CORRIGENDUM-I Dated 18.09.2025
GEM BID REF. NO. GEM/2025/B/6632581 Dated: 04-09-2025

Reply to bidders queries have been tabulated below:

SPECIFIC REQUIREMENT'S (Section- Project)
C/ENGG/SPEC/SEC-PROJECT/SPECIFIC REQUIREMENT REV NO 10

TYPICAL ARCHITECTURAL DRAWING OF SUBSTATION AUTOMATION SYSTEM (Without Process Bus) for New Substation

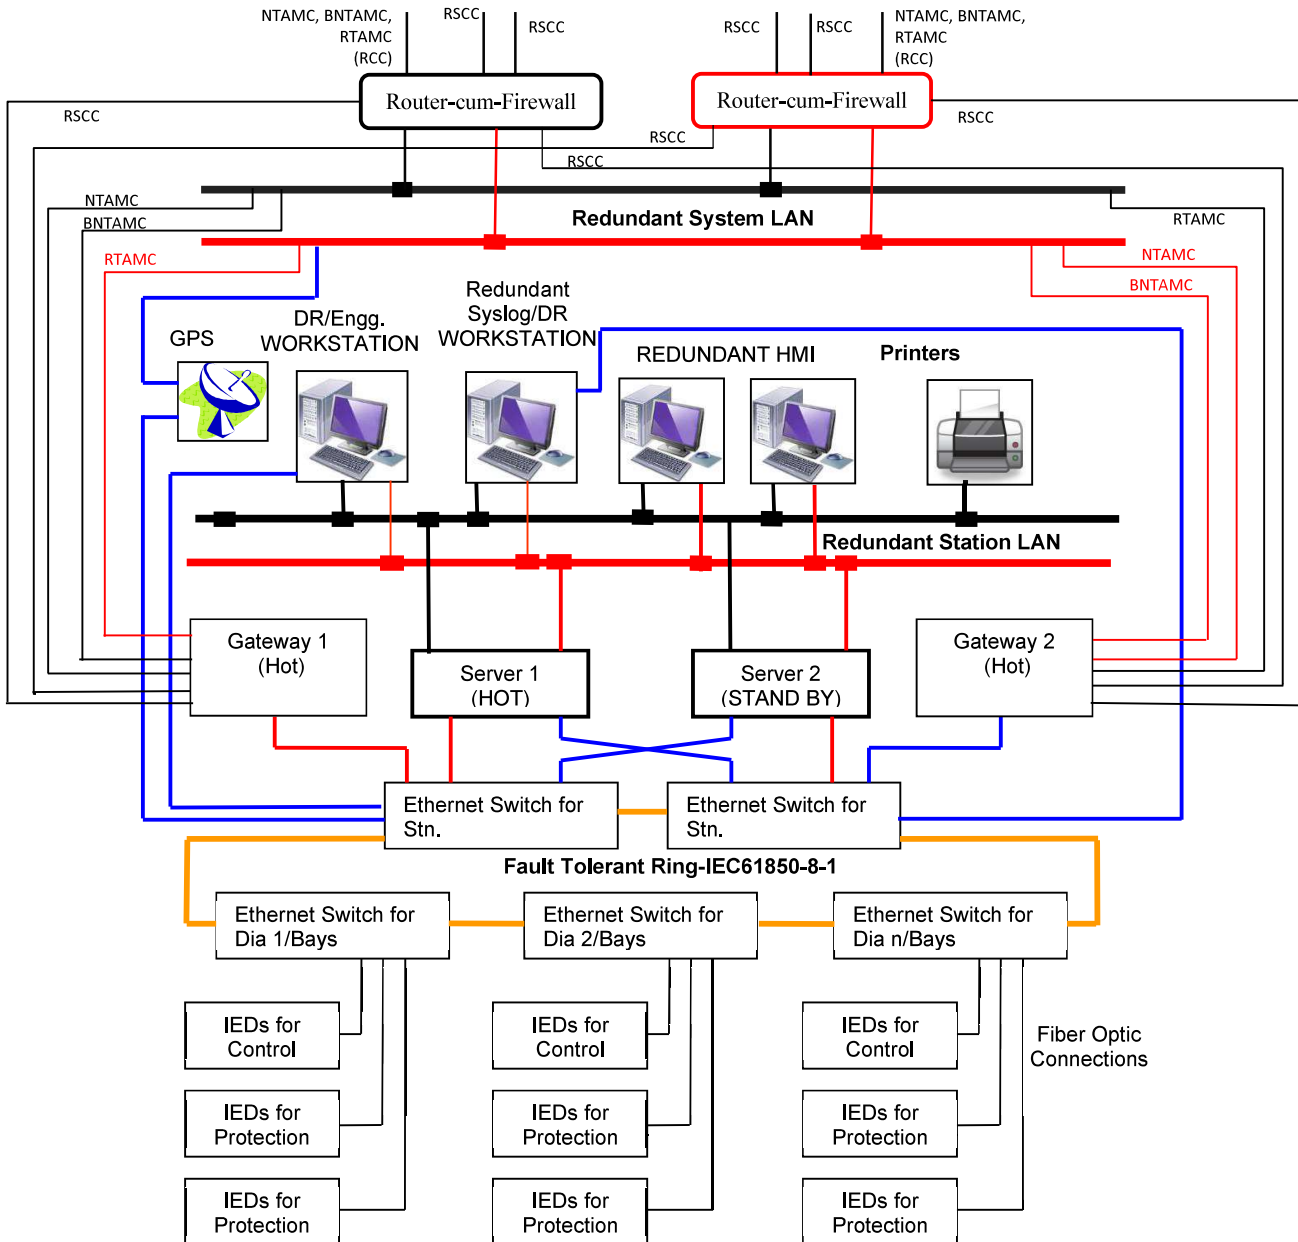
S.No.	Clause No.	Amended As (As per Specific Requirement Rev 10)
L.	Section SAS	Rev 04
1.	Typical Architectural Drawing of SAS (Without Process Bus)	TYPICAL ARCHITECTURAL DRAWING OF SUBSTATION AUTOMATION SYSTEM (Without Process Bus) stands replaced by <u>Annexure-S5</u>
